Council Agenda Correspondence

SUBJECT: ITEM 8A – REVIEW OF AN INITIATION OF A GENERAL PLAN AMENDMENT, REZONE, AND ANNEXATION TO FACILITATE BROADSTONE VILLAGE, A PHASED RESIDENTIAL PROJECT, AT 12500 AND 12501 LOS OSOS VALLEY ROAD

Staff has received the following questions regarding the Broadstone Village project. Questions with similar themes have been combined in the responses below. The questions are **bolded** with staff's responses shown in *italics*:

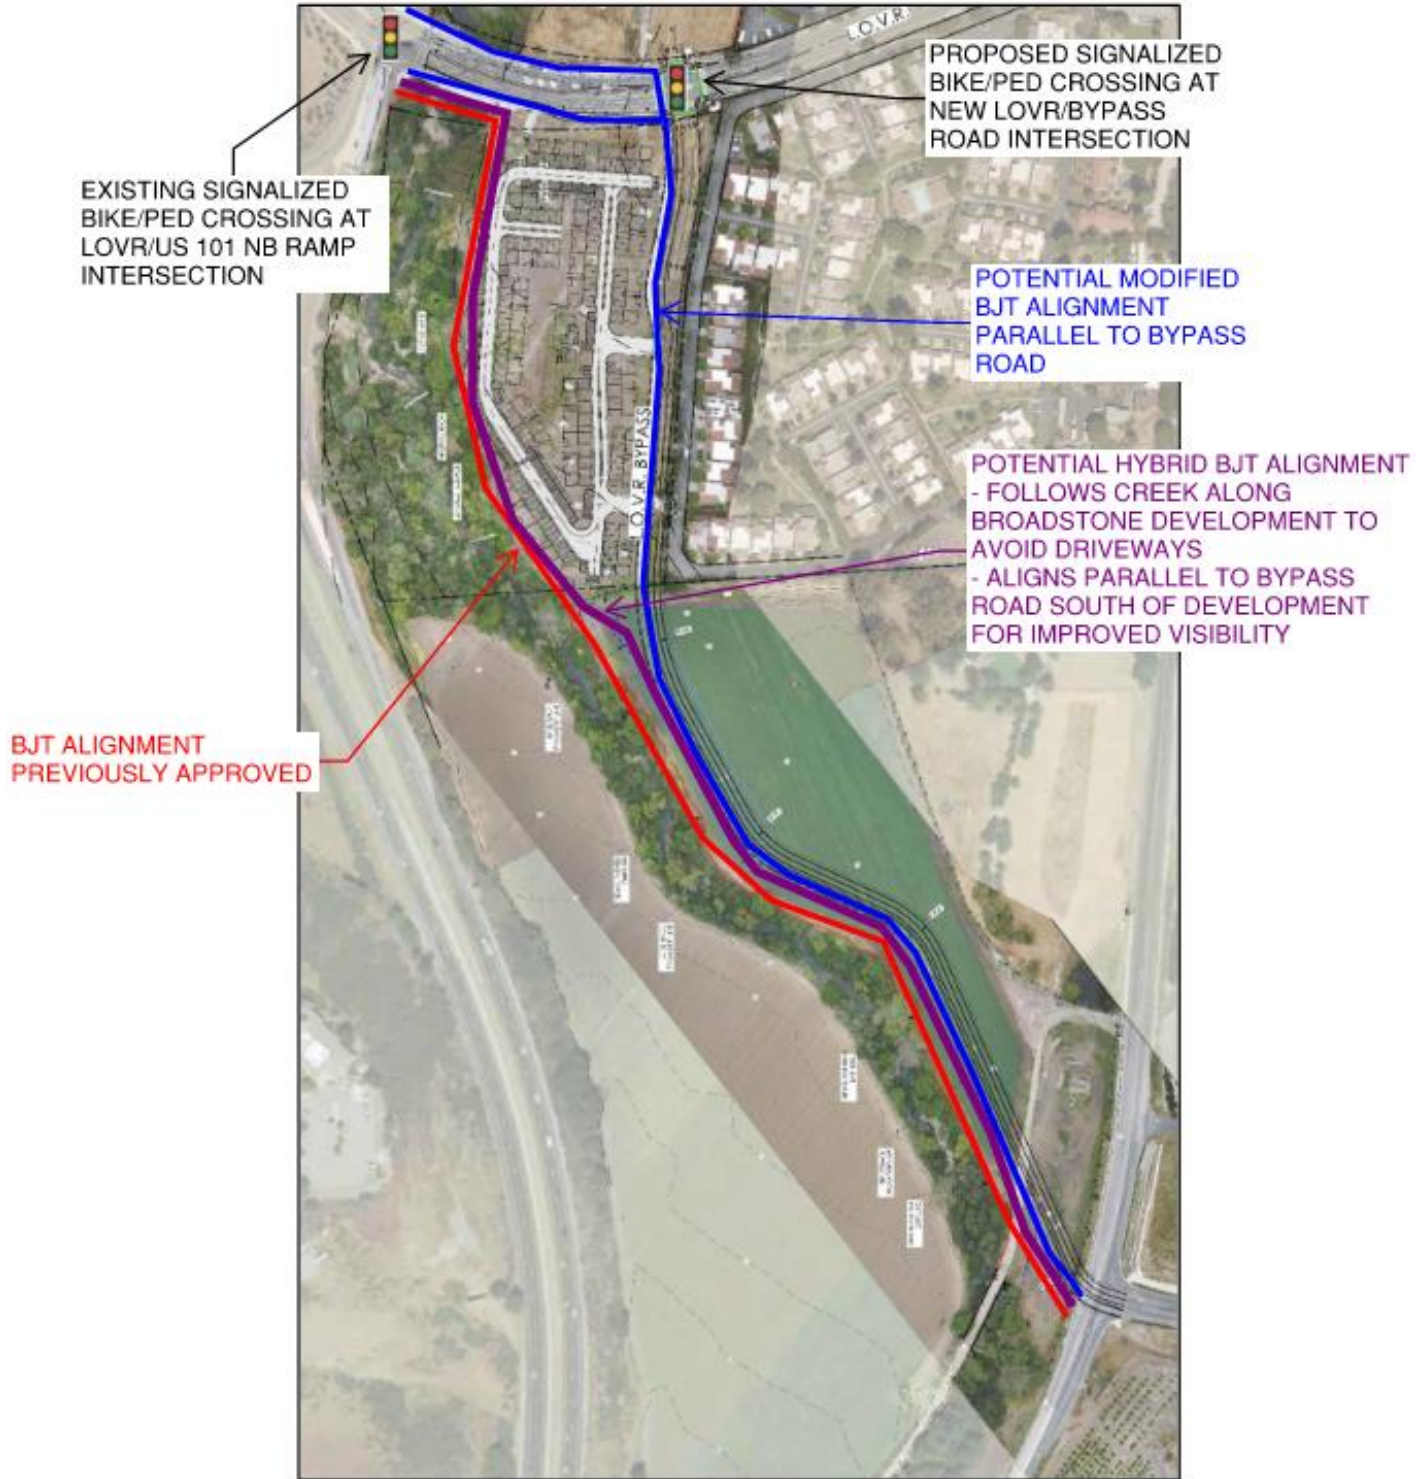
- 1) Why does the project include a realigned Bob Jones Trail extension that runs alongside the LOVR Bypass between LOVR and South Higuera, instead of the previously proposed pathway alignment along San Luis Creek?**

- 4) The applicant indicated three reasons for the BJT realignment:**
- a. Alignment with county land and lack of county permission to build the BJT in the riparian zone.**
 - b. Distance from creek (environmental concerns). Previous approved alignment was too close to the creek.**
 - c. Safety, cleanliness**

- 5) Will the connection between the existing BJT and the new BJT be fully separated from LOVR? Rendering on page 290 of the staff report shows separation in the northern new development but seems to move out to LOVR on the city land.**

The applicant has proposed a modified Bob Jones Trail alignment that runs parallel to the proposed LOVR Bypass Road primarily for the purposes of placing the trail in a more visible location to reduce potential for undesirable behaviors (i.e. illegal dumping, camping, etc.) and public safety concerns for trail users. The modified alignment would also place the path outside of the creek setback and riparian zone, reducing potential for environmental and flooding concerns. It should also be noted that, while the City allows construction of shared-use paths within creek setbacks with approval of a setback exception request, the City's Active Transportation Plan recommends locating shared-use paths outside of creek setbacks.

The alignment for this particular segment of the Bob Jones Trail was previously evaluated in a 2013 study, which recommended a preferred trail alignment that follows the creek corridor. The 2013 study recommended a Creekside alignment primarily to reduce impacts to the adjacent agricultural fields and farming operations. The 2013 study did note that if the future LOVR Bypass is advanced prior to the Bob Jones Trail construction, the "pathway would align with the Bypass and include separation from the roadway".

Ultimately, the project applicant and staff are supportive of (a) retaining the Bob Jones Trail alignment along the creek as previously approved, (b) aligning the trail parallel to the Bypass Road as proposed in the current Broadstone Village Project Plans, or (c) exploring a hybrid alternative that aligns the trail parallel to the creek along the development site to avoid driveway conflicts before aligning parallel to the Bypass Road south of the development to increase visibility. Attachment A (Bob Jones Trail Alignment Options), included in this correspondence, provides an illustrative map showing these options.

The reasons for the proposed modified Bob Jones Trail alignment are summarized in the previous responses above, as well as confirmation that the applicant and City staff would be supportive of the previously approved alignment or the modified alignment proposal, pending input from the Council, ATC and community. The City has not had direct conversations with the County regarding the modified trail alignment; however, the County has indicated that annexation of the Hayashi Property (APN 076-081-030) by the City would be required to support the proposed LOVR Bypass Road and Bob Jones Trail extension, which would allow the roadway and trail to be designed pursuant to City standards and policy direction.

Final design details for the connection between the existing Bob Jones Trail terminus and the proposed extension south of LOVR will be refined pending input from the Council, Active Transportation Committee, and community. There are opportunities to provide this connection as a Class I bikeway (shared-use path) or via separate Class IV bikeway (protected bike lane) and sidewalks, or a combination of the two, on the north or south sides of LOVR, depending on whether the LOVR Bypass Road and new signalized intersection are recommended for advancement. Either way, the intent is to provide a facility that is physically separated from LOVR traffic.
